Design Refinement/Environmental Re-Evaluation Memo

**I-43: Brown Street to Capitol Drive
City of Milwaukee
Milwaukee County**

**Project ID: 1228-22-00
September 13, 2022**

Subject: I-43: Brown Street to Capitol Drive, Project Design ID: 1228-22-00

FILE NAME: S:\DOT\DOT_SE\190224_143_N-5_FREEWAY_NORTH-HAMPTON\DESIGN\12282270\SHEETSPLAN\021201_PD.DWG PLOT DATE: 7/20/2022 11:34 AM PLOT BY: DANIEL VOLK PLOT NAME: PLOT SCALE: 1 IN:100 FT WISDOT/CADD SHEET 42

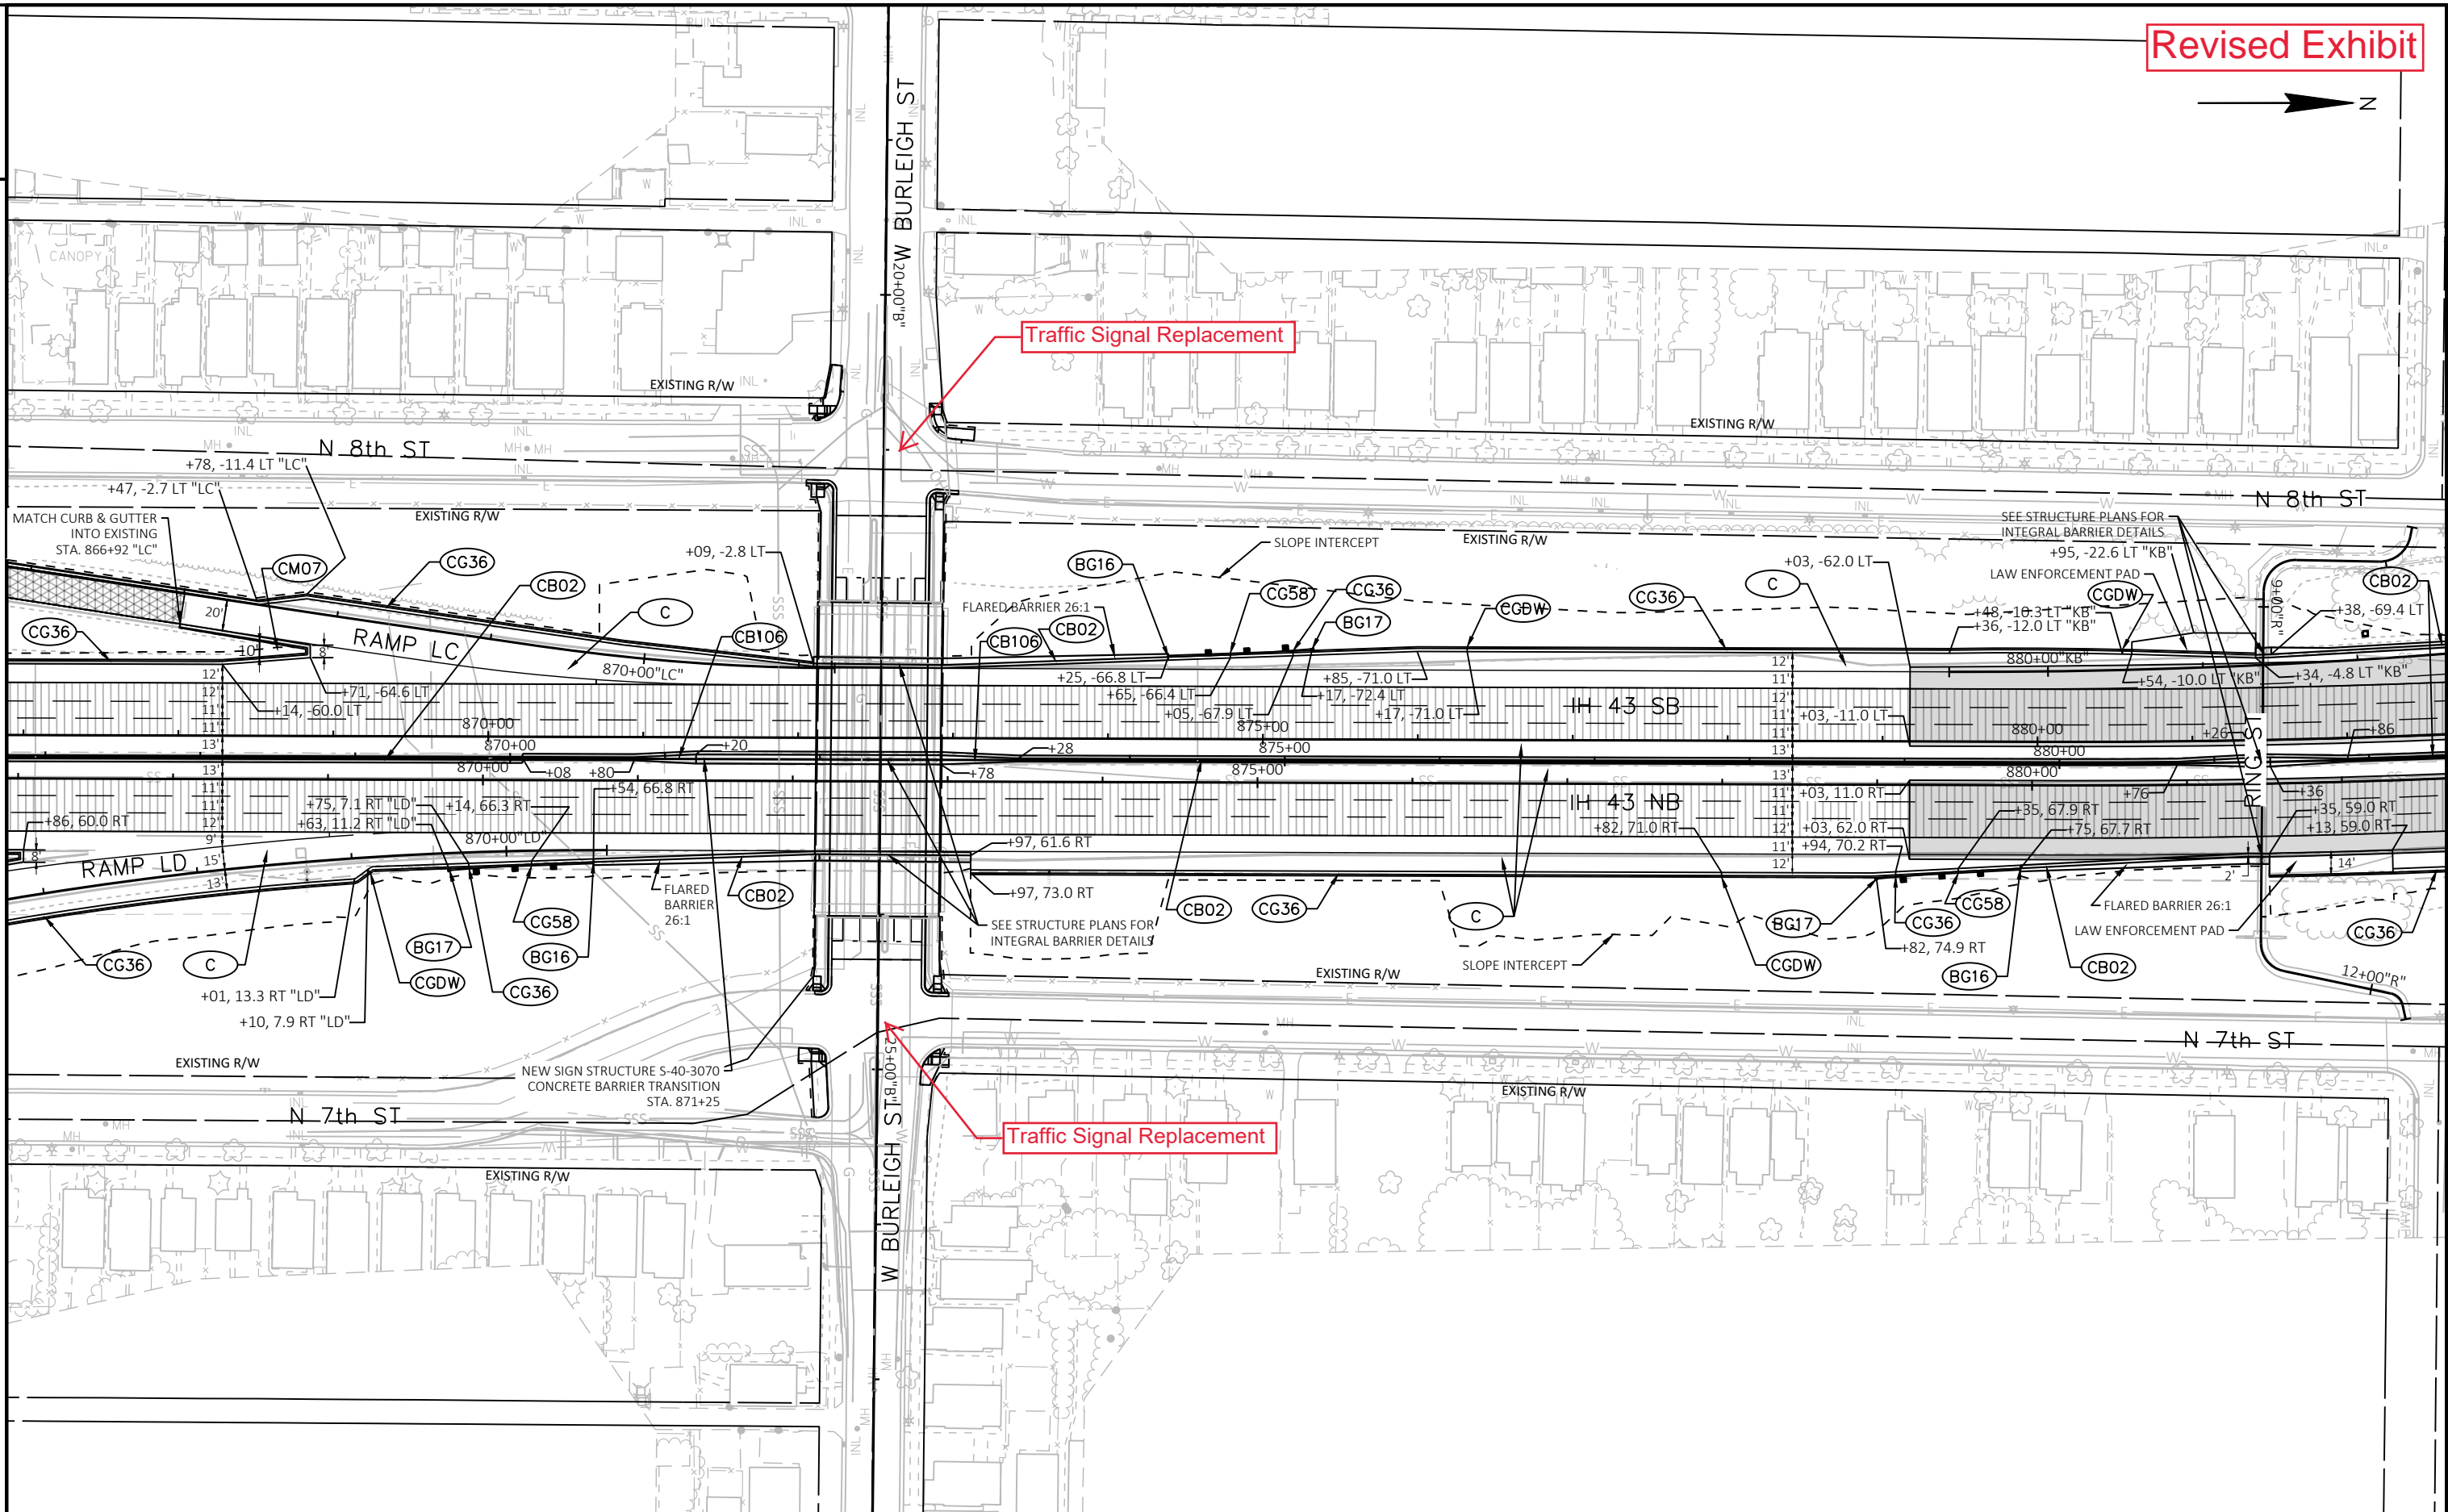
The original plan set overview sheet from the ER and a revised version with the complete scope are attached as Exhibit 1. More detailed plan sheets, consisting of the original provided in the Section 106 amendment and revised plan sheet, are attached in Exhibit 2.

Regarding the Section 106, the plan sheets in the original request for the project to be placed on the Screening List for archeology on September 11, 2020 include work within the subject intersections. Furthermore, the amended Section 106 plan sheets sent to Cultural Resources on February 21, 2022 further defines the intersection work.
